DEVELOPMENT SERVICES COUNCIL REPORT

File No: DP 22-26

Subject: **DP 22-26; Development Permit with Variances; 3401 Sundance Drive**

Figure 2: Revised turnaround with loading space

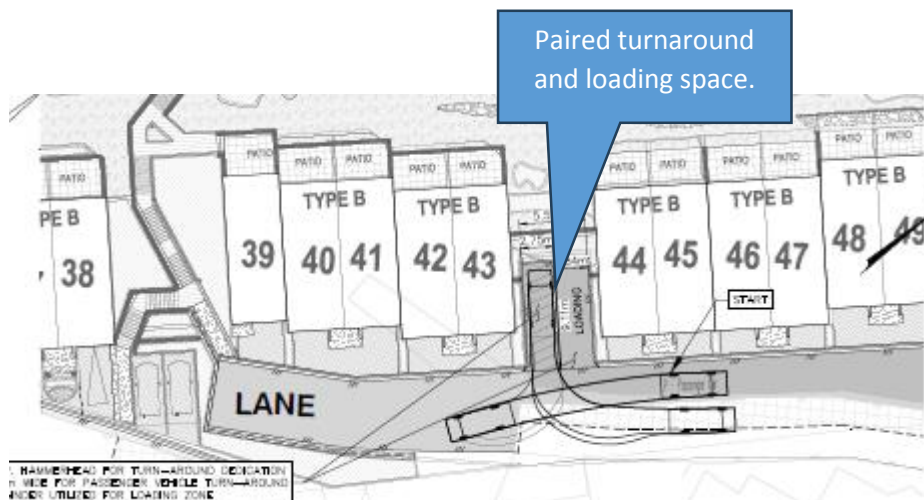
- The proposal now includes an additional turnaround for passenger vehicles near the terminus of the Ensign Lane extension and loading space (Figure 2).

- The loading space dimensions will however require a variance to reduce the minimum dimensions (width) of a loading space from 3.0 m x 9.0 m to 2.8 m x 9.0 m – see variance No. 6.

Figure 3: New laneway access to circumvent trespass on adjacent private property.

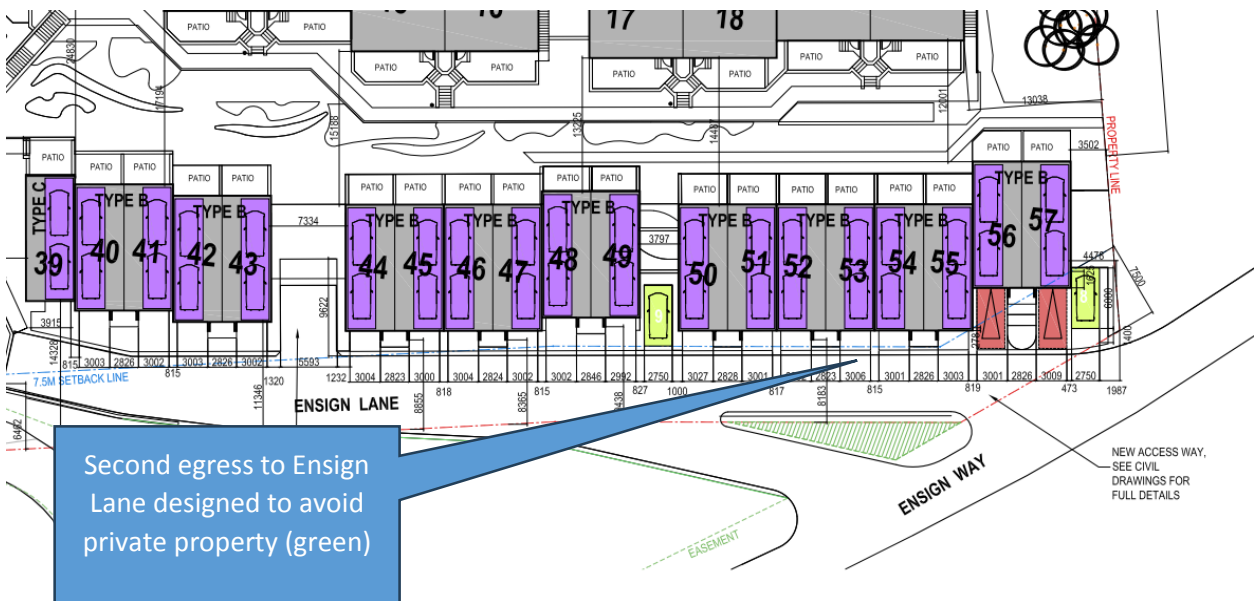
- The applicant has revised their design to circumvent the private triangular piece of property belonging to the adjacent property owner (Figure 3). This has created a second egress to Ensign Lane, north-east of the triangular piece of land.
- The modification to the Ensign Lane extension access (units 39-57) now occurs over the subject property and private access easement only.
- Staff have concerns that this access poses practical connection due to grading changes that will need to be addressed as part of detailed design. These grading challenges may result in disturbance to lands outside of the applicant’s property.

Figure 5: Turning movement for access to Unit 39

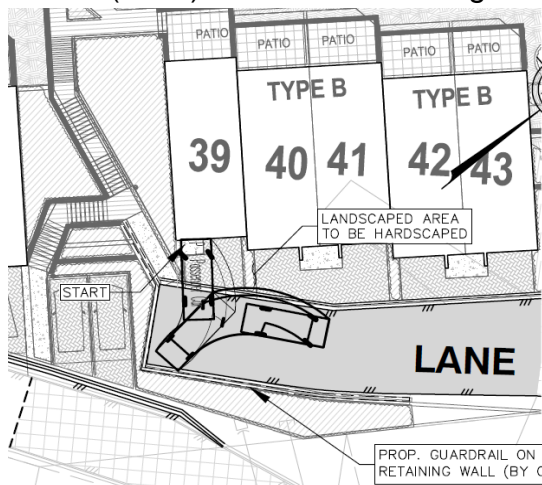
- The applicant has revised their proposal to widen the lane at the terminus of the Ensign Lane extension adjacent to Unit 39 to accommodate turning movements for a 5.6 m passenger vehicle (Figure 5). Staff note that a crew cab Ford F150 with a 5.5 ft (short) box is 5.8 m in length.

- Staff have noted that the landscape plan proposes a 0.4 m landscape wall and shrub bed located within the path of the turning radius. The applicant has confirmed they would hardscape this area to ensure the turning movements would be accommodated. This would be noted on the permit drawings and confirmed at time of building permit.

- The drawings provided by the applicant show a guardrail proposed on top of the retaining wall south of unit 39 (Figure 5), to be designed by others at time of building permit and in conjunction with the 3.5 m retaining wall.

- While an improvement to the design is noted from the original submission, staff have concerns with safety of this access due to the tight turning radius, the 3.5 m elevation difference from the lane and the surrounding area, and the fact that no snow deposition area has been provided (see point 5 below).

Figure 6a: laneway improvements (i.e., widening and safety barrier)

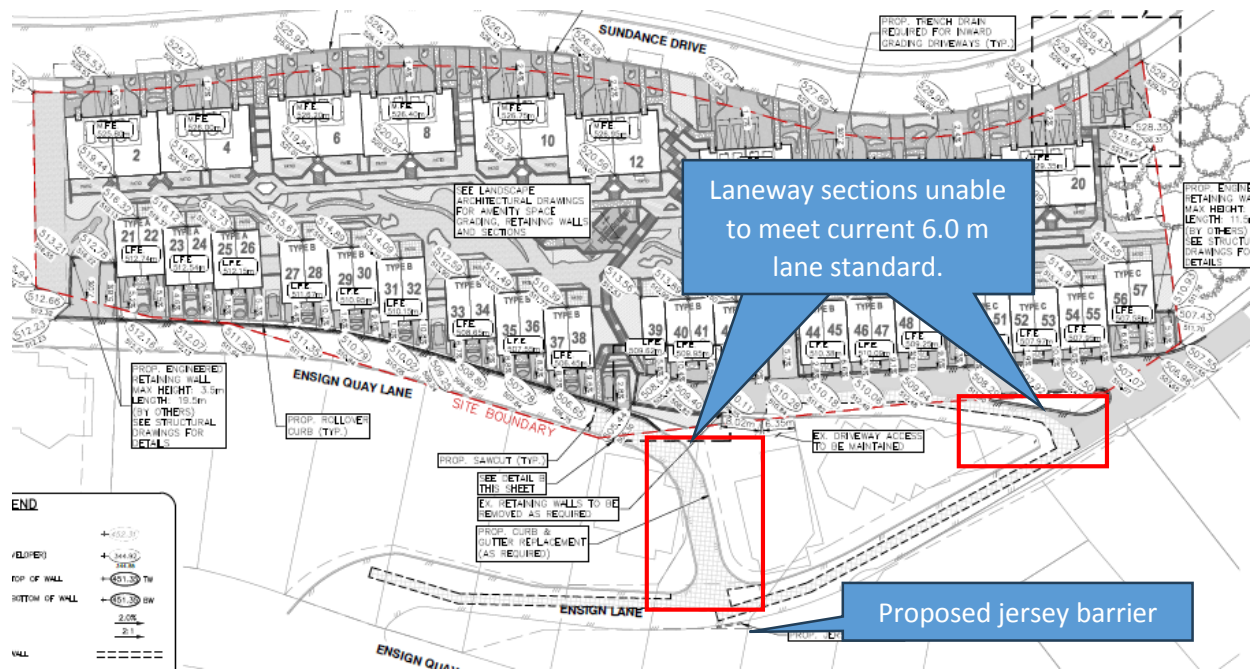
- To address safety concerns noted at the May 16 meeting, a jersey barrier is proposed at the base on Ensign Quay Lane to provide some security for vehicles, to mitigate potential roll-over at the base of the slope at the Ensign Quay Lane / Ensign Lane intersection (Figure 6a). This work may require additional approvals from easement holder(s) or landowner(s), as the proposed location of the barrier appears to be outside of the existing easement.
- The proposal includes lane widening to 6.2 m on both Ensign Quay Lane and the Ensign Lane extension to meet the (6.0 m) drivable surface reflected in the City's Hillside Lane Standard. However, there are two existing sections of laneway that

are unable to meet the hillside standard width due to existing site constraints (retaining wall and house - Figure 6a & 6b). These sections are considered legal non-conforming, however do present circulation challenges given the significant increase in traffic from the units.

- Some of the laneway widening, driveway, loading and turnaround construction is proposed within the private easement boundary. Improvements within the private easement would require approval from neighbours that are party to the easement agreement; therefore, this work may not be completed as proposed. Staff have included an alternate motion that requires confirmation of the approval of easement holders prior to issuance of the development permit.

Figure 9: Variance to the number of loading spaces.

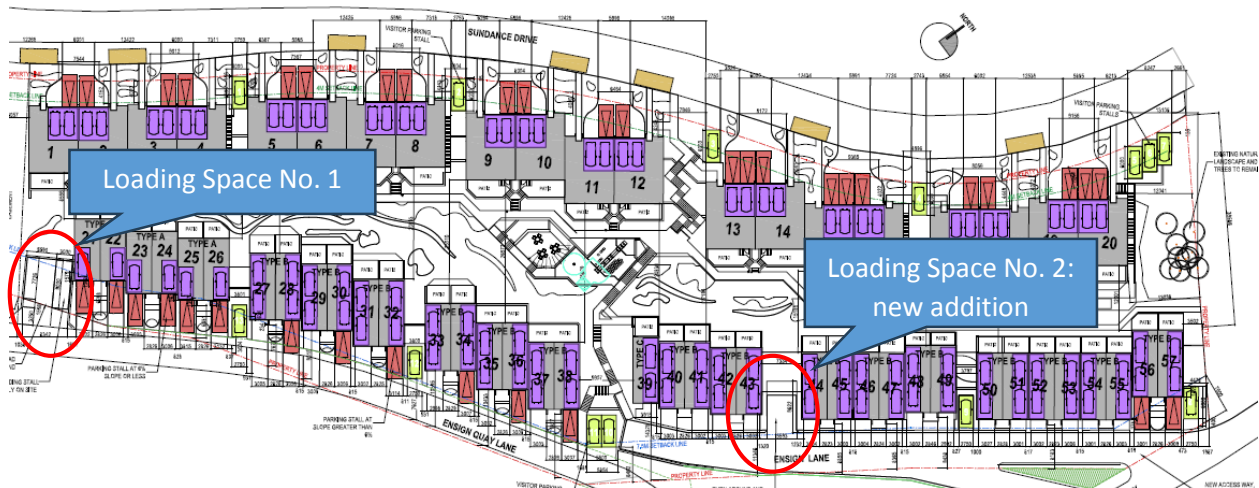
5. Reduction to the minimum number of loading spaces from four to two spaces (S.4.10.1(a)) (Figure 9).

- This variance has been reduced from the original submission with the addition of a loading space on the Ensign Lane extension (Figure 9).
- Each laneway now includes one loading space.
- Loading can otherwise be accommodated on the Sundance Drive units via driveway or on-street parking.
- Loading space No. 1 will require approval of the adjacent property owner due to the installation of a retaining wall within the easement area.

Figure 10: Variance to loading space dimensions.

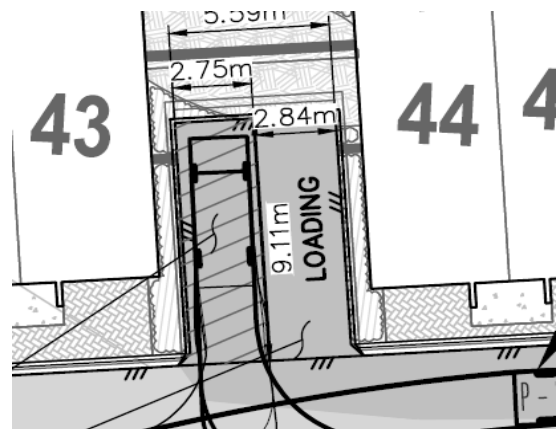
6. To reduce the minimum dimensions of a loading space from 3.0 x 9.0 m to 2.84 m x 9.0 m (S.4.10.2(a)) (Figure 10).

- This variance is required to pair the loading space with a turnaround on the Ensign Lane extension and not impact the unit count.
- The width of the loading space is slightly less than standard, by 0.16 m.
- Staff do not have concerns related to this variance.

Figure 11: Variance to retaining wall height x3.

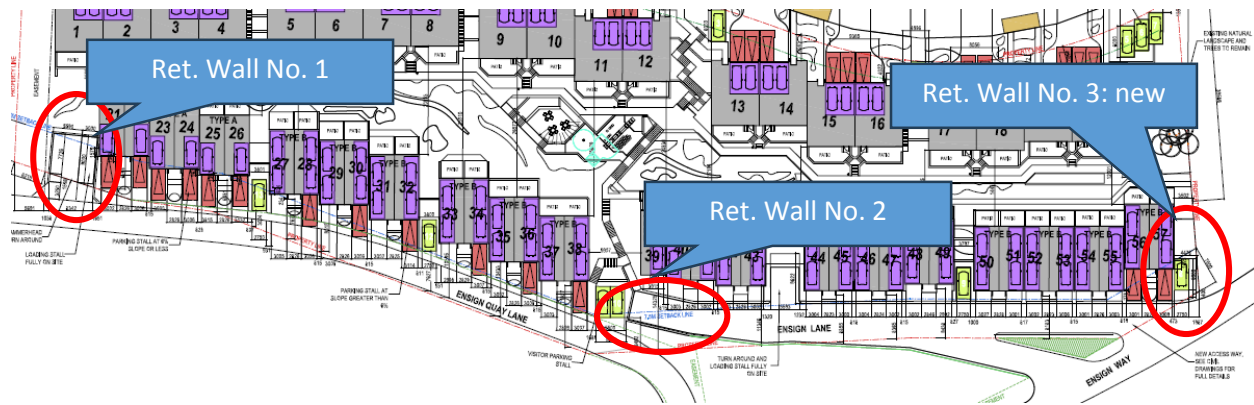
7. To increase the maximum height for three individual retaining walls from 2.5 m to 3.5 m (S.3.14.1) (Figure 11).

- This variance has been modified to include an additional 3.5 m retaining wall to accommodate the revised laneway access design and visitor parking space adjacent to Unit 57.
